UNITED STATES PATENT AND TRADEMARK OFFICE

APPLICATION NO.	FILING DATE	FIRST NAMED INVENTOR	ATTORNEY DOCKET NO.	CONFIRMATION NO.
10/810,905	03/26/2004	Haowen Bu	TI-36637	9390
23494	7590	10/31/2006	EXAMINER	
TEXAS INSTRUMENTS INCORPORATED P O BOX 655474, M/S 3999 DALLAS, TX 75265			STARK, JARRETT J	
			ART UNIT	PAPER NUMBER
			2823

Office Action Summary	Application No.	Applicant(s)	
	10/810,905	BU ET AL.	
Examiner	Art Unit		
Jarrett J. Stark	2823

DETAILED ACTION

FIG. 4

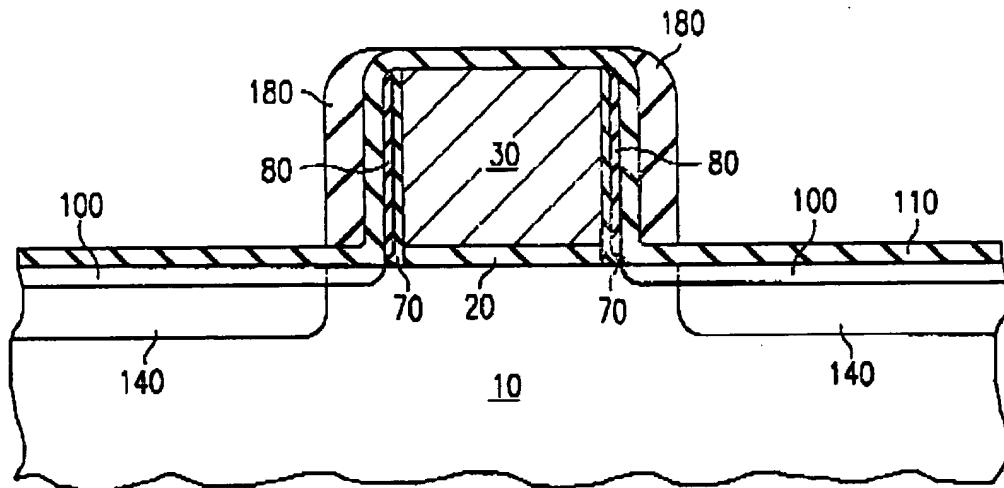
Regarding claim 1, Bu discloses a method for fabricating a CMOS transistor structure, comprising the steps of: (see Bu, Figs. 2 - 4)

providing a semiconductor substrate having a P-type dopant region to support an N-channel transistor and an N-type dopant region to support a P-channel transistor, each of the N-type dopant and P-type dopant regions having an overlying gate stack including a conductive gate;

forming lightly-doped extension regions in the semiconductor substrate adjacent each gate stack;

forming a layer of insulating material over the lightly-doped extension regions;

forming an interfacial layer of nitrogen at the interface of the insulating layer and the lightly-doped extension regions; forming source and drain regions in the semiconductor substrate adjacent to each of the gate stacks.

Bu does not expressly disclose forming a capping layer of contiguous silicon nitride over the semiconductor substrate and each of the gate stacks; annealing, with the capping layer in place, the extension and source and drain regions; and removing the capping layer after the annealing.

FIG. 6

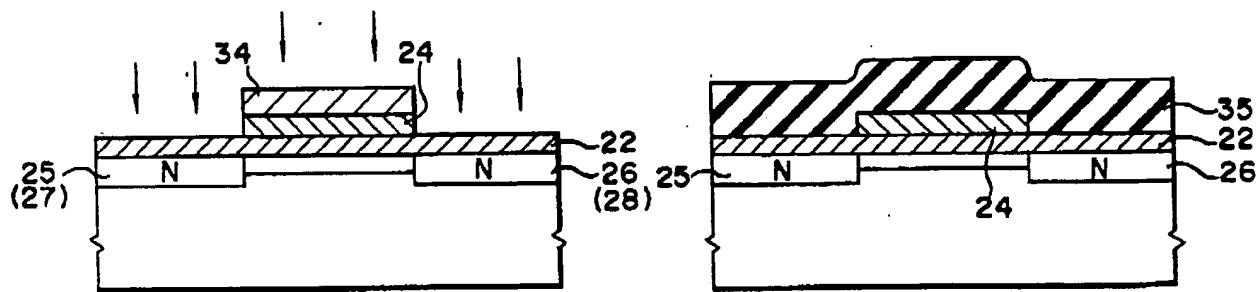
Iwasaki discloses the method of cap-annealing with a protective film shown below in Figs 6-7 that can be comprised of several materials including SiN (Iwasaki Col.8 lines 18-25).

At the time of the invention, it would have been obvious to a person of ordinary skill in the art to include a SiN protective capping layer for use during the annealing step in order to protect the device or layers during the annealing process. Therefore, it would have been obvious to combine Iwasaki with Bu to obtain the invention as specified.

According to Iwasaki Cap-annealing is a safer method than that of capless annealing (Iwasaki, Col.8 lines 15-17). This causes mutual-conductance gm to increase and further improves the operation speed. (Iwasaki, Col.8 lines 8-9).

FIG. 2F

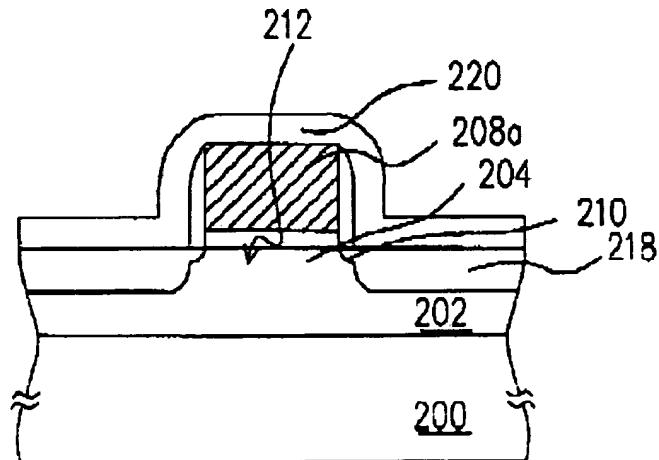
Iwasaki does not specifically disclose that the capping layer can be used during the fabrication of CMOS structures. However, it was notoriously well known in the art at the time of the invention that cap-annealing can be used when forming a CMOS transistor also. This is shown by Chang in Figure 2F and columns 4 lines 40-66. Chang teaches forming a capping layer, annealing, and then removing the capping layer (220) during the fabrication of a CMOS transistor.

It would have been within the scope of one of ordinary skill in the art at the time of the invention to combine the teachings of Bu and Iwasaki and/or Chang to enable the annealing step of Bu to be performed according to the teachings of Iwasaki and/or Chang because one of ordinary skill in the art would have been motivated to look to alternative suitable methods of performing the disclosed annealing step of Bu and art recognized suitability for an intended purpose has been recognized to be motivation to combine. MPEP 2144.07.

FIG. 3

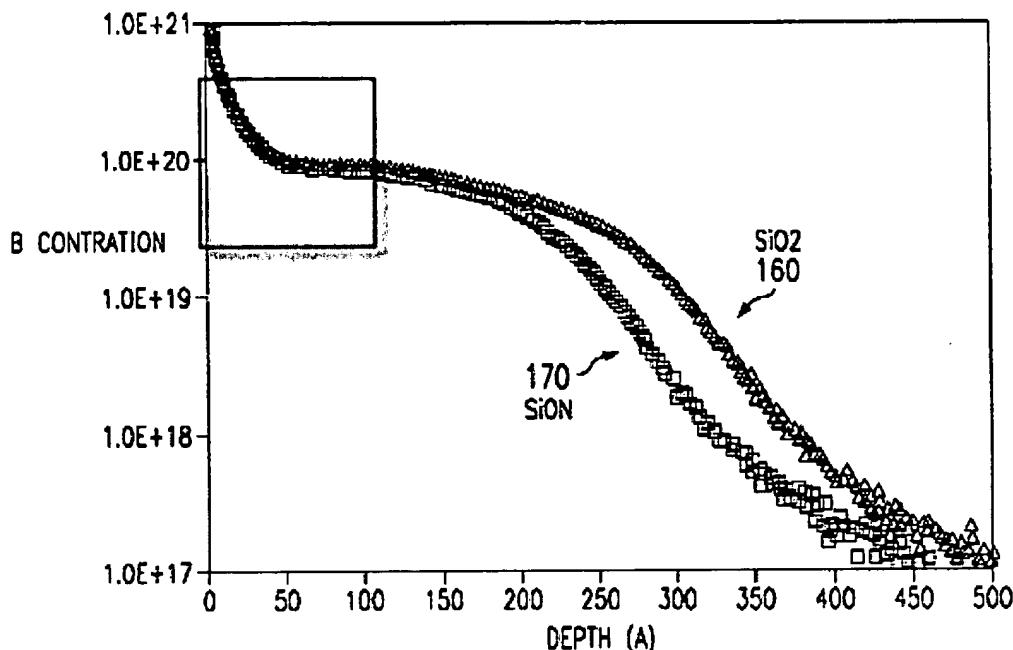
Regarding claims 2 & 3, Bu in view of Iwasaki in further view of Chang
discloses the method of claim 1 wherein the extension regions for the PMOS transistors have a dopant concentration in the range of about 1-2 e20 atoms/cm3. (see Bu, Figs. 3)
